# CHEVROLET

# SERVICE NEWS

MAY, 1960

Fig. 6—Air Horn Gaskets—Production and Service

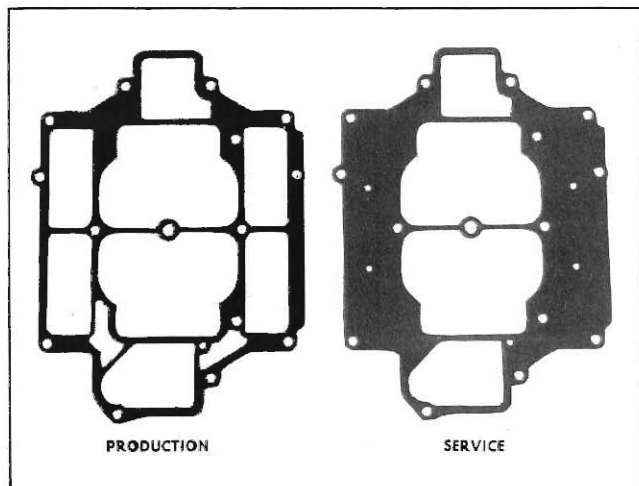
Some servicemen have expressed concern with regard to the construction of the air horn gasket supplied with Kit 7015827. The service gasket, (fig. 6) is made slightly different than the production gasket to eliminate the possibility of the engine cutting out on turns during hot weather operating conditions.

The standard production gasket is used with four barrel carburetors, Part Nos. 7013004, 7013006, 7013010 and 7013012. When the serviceman is

confronted with this problem of the difference in construction of the original equipment gasket compared to the service replacement gasket, by referring to Figure 6 he can be assured that the service replacement gasket being installed is correct.

Fig. 7—Four Speed Transmission

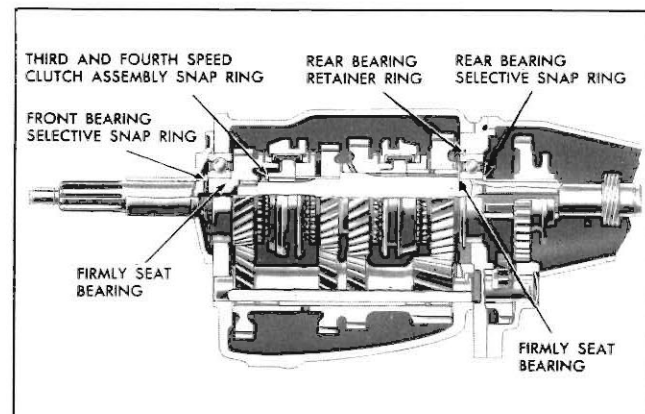
### REVISED FOUR SPEED TRANSMISSION SERVICE PROCEDURE

This revised four speed transmission service procedure covers (1) the selective fit snap rings used at the front of the front bearing and at the rear of the rear bearing (2) the snap ring used at the front of the third and fourth speed clutch assembly and (3) the rear bearing retaining ring. Reference is also made to firmly seat the bearings.

Briefly, the selective fit snap ring used at the front of the front bearing and to the rear of the rear bearing is available in three sizes maintaining a clearance of .000" to .005". The snap ring used at the front of the third and fourth speed clutch assembly and the rear bearing retaining ring are not selective.

The following information should be included in the 2nd Edition of the 1960 Passenger Car Shop Manual pages 12-10, 12-11 and 12-12:

1. Immediately after step 4, page 12-10, add the following statement: Firmly seat the bearing against the shoulder on the mainshaft.
2. Following step 5, page 12-10, add the following paragraph:  
This snap ring is available in three thicknesses, .087", .093" and .099". Use the ring that will produce .000" to .005" clearance between the rear face of the bearing and the front face of the snap ring. Refer to Figure 7.
3. Delete the note following step 10, page 12-11.
4. Step 11, page 12-11, should read as follows: Install the rear bearing retainer plate, (fig. 21). Spread the snap ring in the plate to allow the snap ring to drop around the rear bearing

and press on the end of the mainshaft until the snap ring engages the groove in the rear bearing.

5. Immediately after step 3, page 12-12, add the following statement: Firmly seat bearing against shoulder on clutch gear.
6. Following step 4, page 12-12, add the following paragraph: The snap ring is available in three thicknesses, .087", .093" and .099". Use the ring that will produce .000" to .005" clearance between the rear face of the snap ring and the front face of the spacer washer.

Fig. 8—Old and New Design Hydraulic Modulators—Turboglide

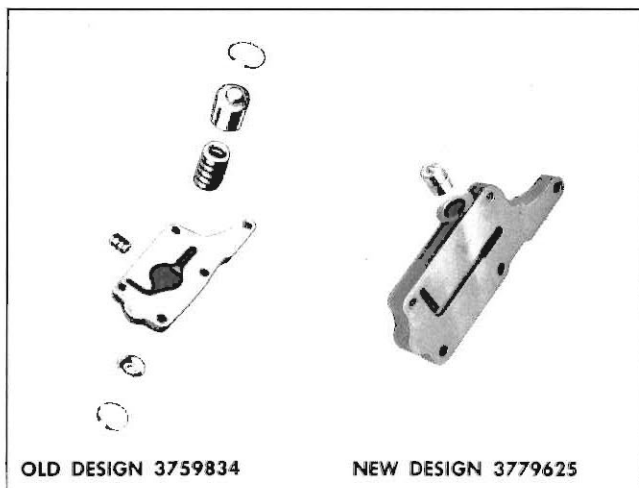
The 1959-60 Turboglide transmission was modified to provide a minimum mainline pressure of 80-90 psi instead of the 45-60 psi used in the 1957-58 models. This change eliminated the need for the vacuum modulator accumulator valve, located in the hydraulic modulator valve body.

A new hydraulic modulator valve body, Part No. 3779625, without the vacuum modulator accumulator valve (fig. 8) is now being installed in the Turboglide transmissions. The previously used valve body, Part No. 3759834 (fig. 8), is available as a service replacement part for 1959-60 transmissions with either the early production valve body, Part No. 3759834, or present production valve body, Part No. 3779625. When valve body Part No. 3779625 becomes available for service replacement it cannot be used for 1957-58 transmissions. The 1957-58 transmissions require an accumulator and also have different diameter hydraulic modulator valves. Use original equipment valve body, Part No. 3745605, for 1957 transmissions and valve body Part No. 3750652 for 1958

transmissions as service replacement valve bodies for these transmission.

Fig. 9—New Design 2nd Turbine Thrust Washer—Turboglide

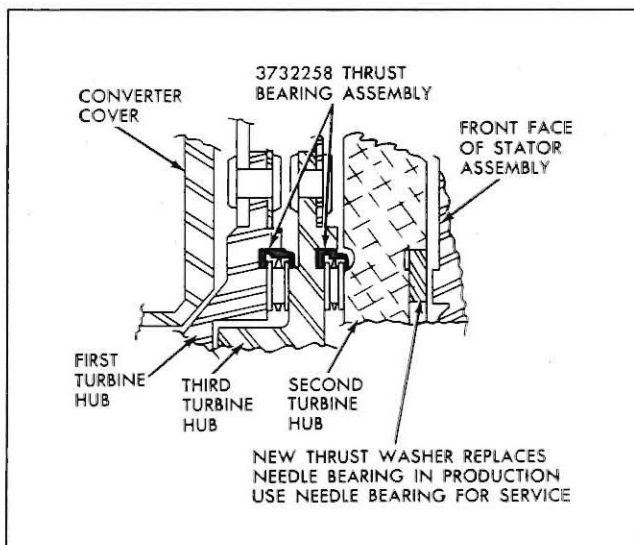
The 2nd turbine thrust washer used in the torque converter of the Turboglide transmission has been changed in production from a needle-type thrust washer to a plain, steel-backed thrust washer. Until the present time, three needle-type thrust washers have been used in the torque converter, one for each turbine, 1st, 2nd and 3rd (fig. 9).

The steel-backed thrust washer is used with service replacement, second turbine assembly Part No. 3760597 as well as being used in the complete transmission assembly Part No. 3759863. However, the new thrust washer will not be serviced separately. Use needle-type thrust washer, Part No. 3732258, as a service replacement part.

Fig. 10—Redesigned Body Electrical Connectors

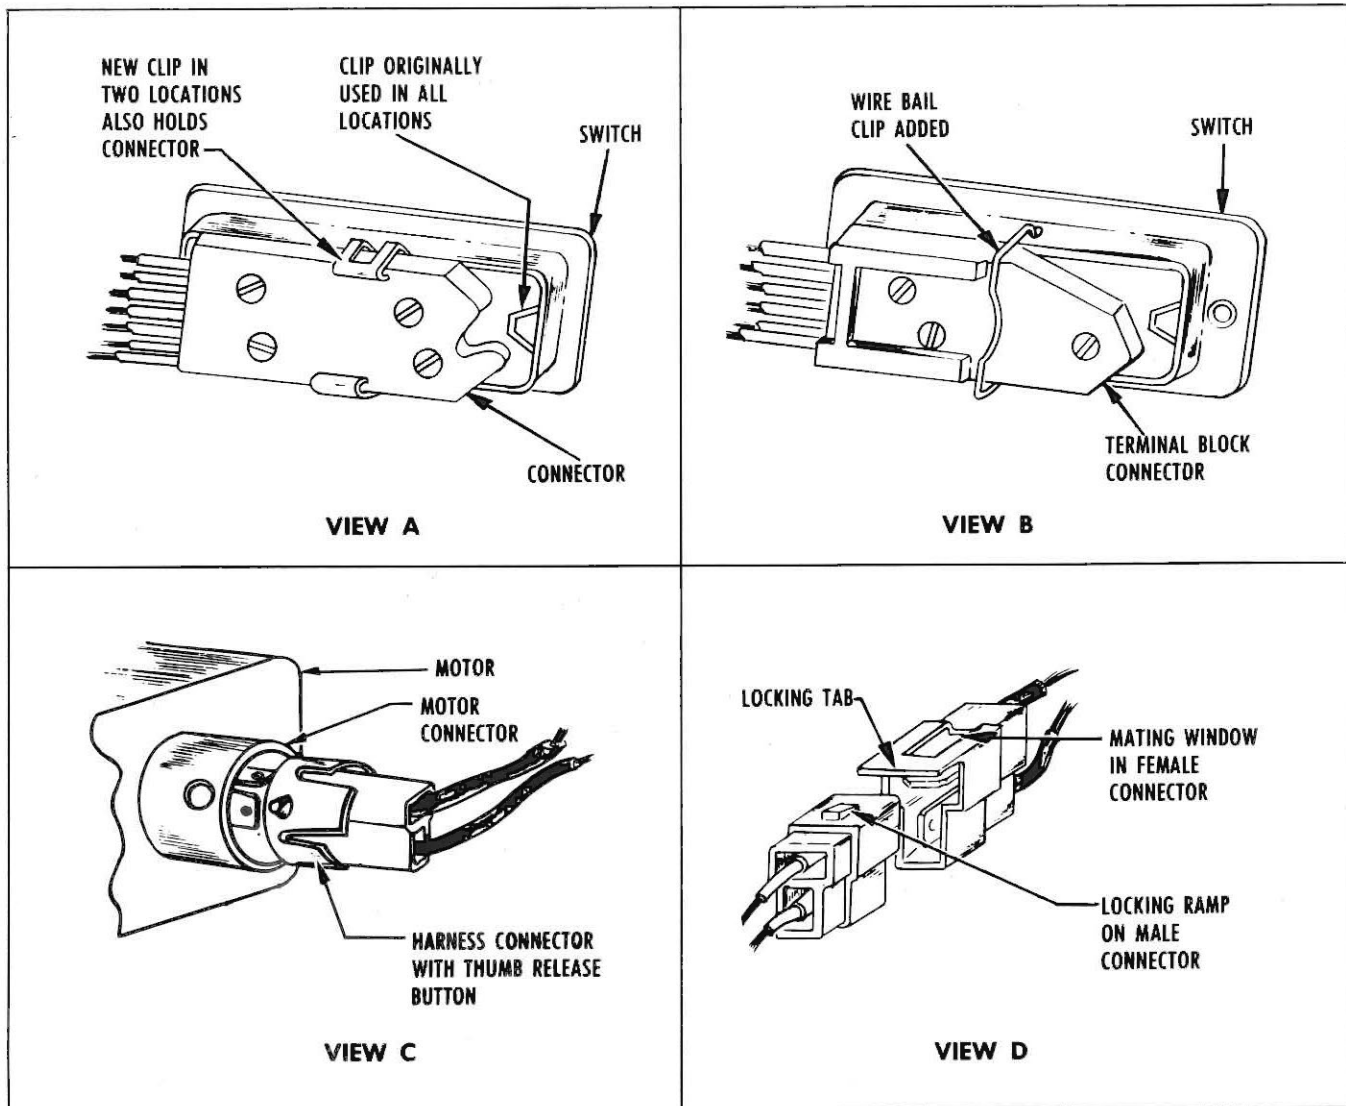
The construction of the body electrical connectors has been redesigned to improve their retention. This will minimize the possibility of electrical failure due to disconnected wires, switches, etc.

Figure 10 illustrates the constructional changes. Knowledge of this information will assist the serviceman when removing these connectors.

The window control switch retaining clips, View A, have been redesigned to provide a positive attachment to the switch terminal. This is the case for all one and four button assemblies. Each switch incorporates two finger type clips which must be spread apart before the switch can be removed from the terminal block.

A wire clip, View B, is used to secure the switch terminal block to the four and six way seat adjuster

control switch. The clip must be removed before the terminal block can be disengaged from the switch.

The electric window and seat motor connector to harness connector, View C, has been revised to permit a button-type locking arrangement to position itself into the motor connector. To remove the harness connector, depress the button, with thumb pressure, then pull the harness connector out of the motor connector. The only precaution to observe when installing the harness connector is to depress and align the release button with the hole in the motor connector.

Locking mechanisms have also been included in the single and double wire harness connectors, View D. The molded in locking ramp, when positioned in the window of the female connector, provides positive retention of the mating parts. To remove the male connector pry up the locking tab

of the female connector, then pull out the male connector.

Fig. 13—Corvaire Oil Filter Gasket

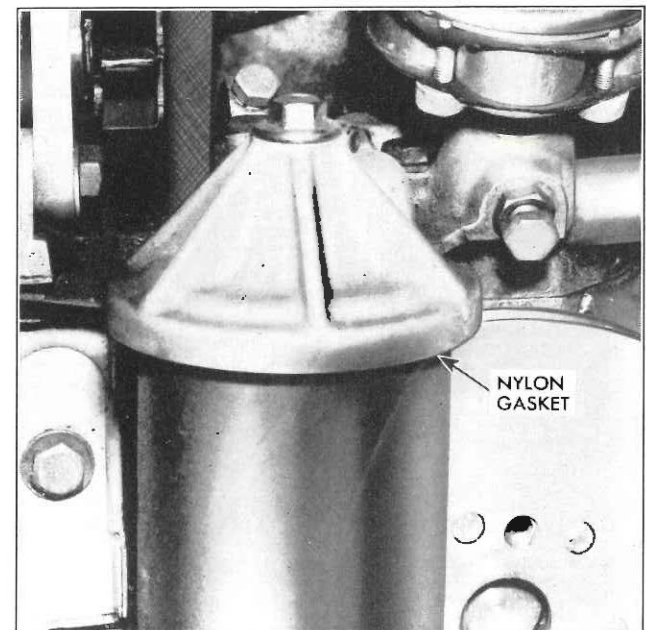
The oil filter center bolt torque specification presented on page 2-6 of the 2nd Edition Corvaire Shop Manual is incorrect. The torque specification should be 9-15 ft. lbs. as stated on pages 6A-51 and 12-6.

The correct amount of torque applied to the oil filter center bolt is very important because if the bolt is tightened to 20-25 ft. lbs. torque as

stated on page 2-6 of the Corvair Shop Manual, the nylon gasket may split, causing an oil leak. An oil leak in this area (fig. 13) can result in the rapid exhausting of the engine oil.

Fig. 14—Corvair Carburetor Float Settings

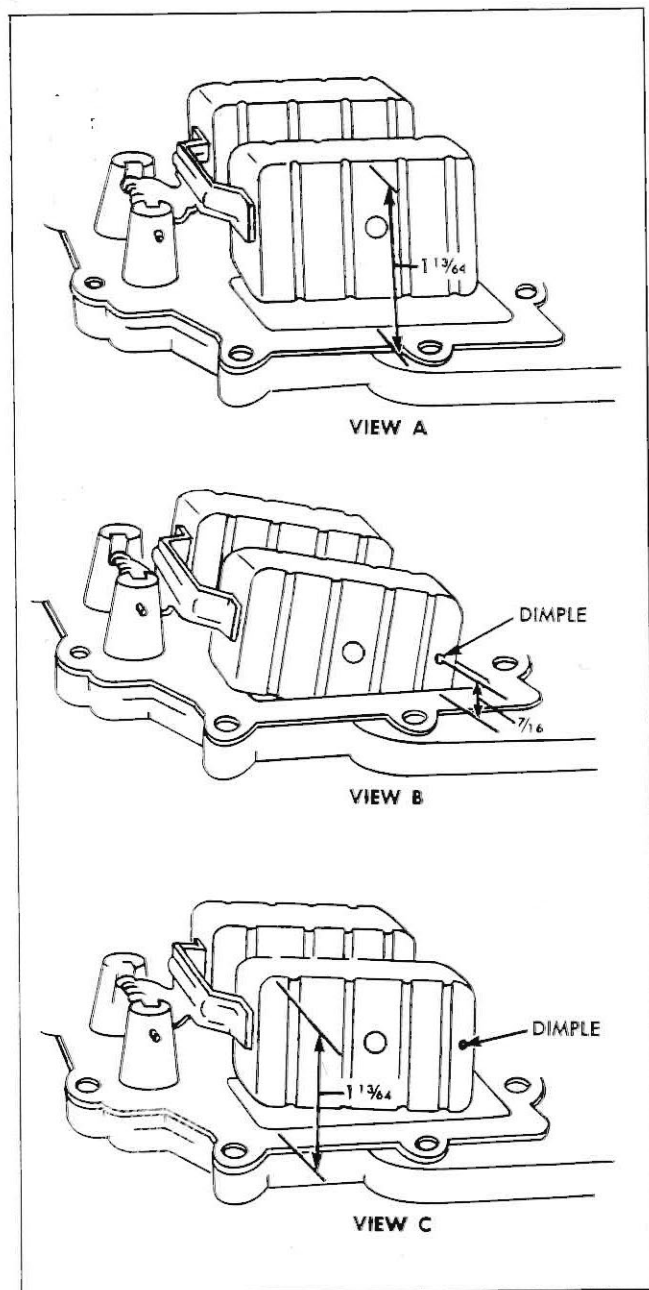
Recent changes in Corvair carburetors make proper carburetor identification necessary to insure correct float setting.

Corvair carburetors Part No. 7015310 (automatic transmission) and Part No. 7015311 (3 speed) use a solid needle valve and a float without

a dimple. Recently these carburetors were changed to include a spring loaded needle valve, seat assembly and a new float with a dimple, carburetor Part No. 7015312 (automatic) and Part No. 7015313 (3 speed). Production difficulties were encountered with this modified carburetor which necessitated replacement of the spring loaded needle valve with the original solid needle valve and seat. These carburetors with the solid needle valve and dimpled float have the same part numbers as the original solid needle valve carburetors, but are identified by the letter "A" stamped on the metal tag. The letter "A" indicates that this carburetor has a dimpled float. In the near future all carburetors will have the solid needle valve and seat assembly and float without the dimple.

Figure 14 illustrates the float setting according to the type of needle valve used and the float identification marks.

The float setting for Carburetor Part No. 7015310 or 7015311 with solid needle valve and float Part No. 7015241 should be  $1\frac{3}{64}$ " from the gasket surface to the top of the float, View A.

The float setting for carburetor Part No. 7015312 or Part No. 7015313 with spring loaded needle valve and float with a dimple should be  $\frac{7}{16}$ " from the gasket to the dimple, View B.

The float setting for carburetor Part No. 7015310 or Part No. 7015311 with the solid needle valve and the dimpled float should be  $1\frac{3}{64}$ ", View C.

It is suggested that the solid needle valve and seat Part No. 7015789 be used as service replacement for spring loaded needle valve and seat assembly. It is also suggested that float and lever assembly Part No. 7015241 (without dimple) be used with solid needle valve and seat Part No. 7015789 as service replacement for all dimpled floats. When making this replacement a float setting of  $1\frac{3}{64}$ " should be used.
